# Service Bulletin

**No 5 2003-12-18**

## Repositioning of the Flow Switch in the White Box

System Applicability: Marinfloc® White Box Fail Safe System (WBS).

<b>MARIN MILJÖTEKNIK AB</b>			<b>WHITEBOX COMPONENT DESCRIPTION</b>	
Draw	Design	Appr	Draw No	Scale
B.C	P.L		LD003	
Date			Rev.	
2003-06-04

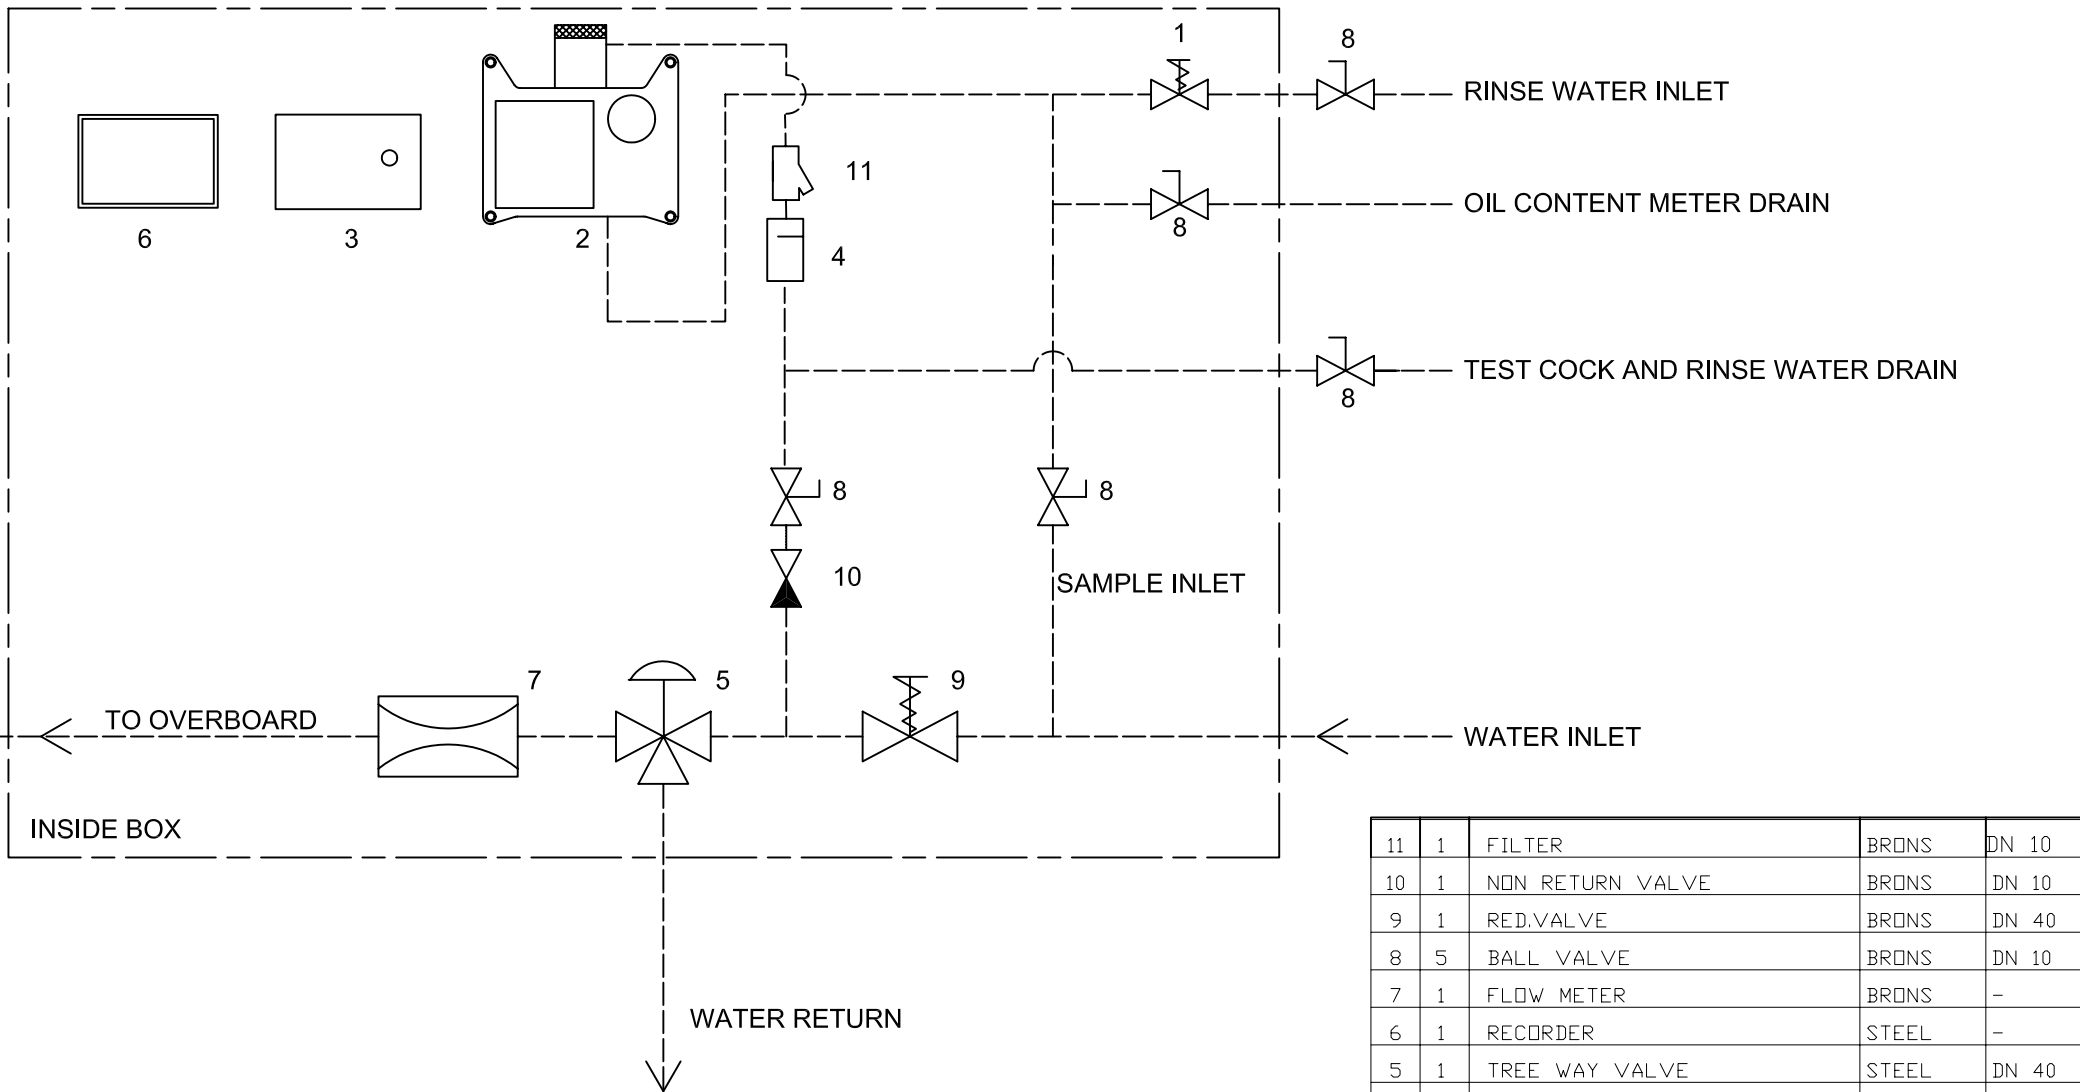
Effective with the delivery of White Box serial no 50013 the flow switch was repositioned to the effluent side of the oil content meter, rather than the inlet.

The repositioning coincided with the upgrade from the plastic prominent flow switch to the stainless steel Honsberg flow switch. The installation of the Honsberg flow switch includes a filter to prevent solids from entering the body of the flow switch. Since this filter could be seen as filtering the sample, the unit was moved to the effluent side of the sample to eliminate this incorrect impression.

The manuals for the White Boxes, from serial no 50013, may have inadvertently included the original drawing, showing the flow switch on the influent side of the oil content meter. This has caused confusion on some ships.

Please check and replace the drawing in the White Box manual with the one attached, showing the correct position of the flow switch on the effluent side of the oil content meter, if required.
